ADDENDUM NO. 2 – July 24, 2025

Christopher Way Pipeline Maintenance

This addendum amends the Contract Drawings and Specifications for this project as follows:

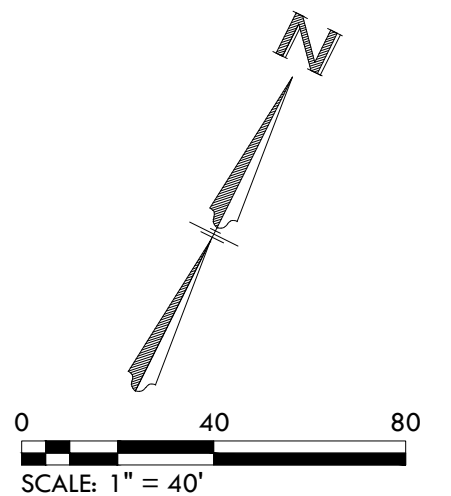
1. CONTRACTOR TO CCTV EXISTING RECYCLED WATER LINE TO VERIFY CONDITIONS AND LATERALS. CONTRACTOR TO CAP AND CUT EVERY LATERAL CONNECTION.
2. CONTRACTOR TO FLUSH OUT AND PRESSURE TEST EXISTING PIPE.
3. ALL PROPOSED PIPE MATERIAL TO BE PVC C900 DR 18.

CONTRACTOR TO CONNECT TO EX. 20"RW
AND INSTALL 20"x16" REDUCER, 16"x16"
90° ELBOW. INSTALL MEGALUG JOINT
RESTRAINTS IN LIEU OF THRUST BLOCKS.
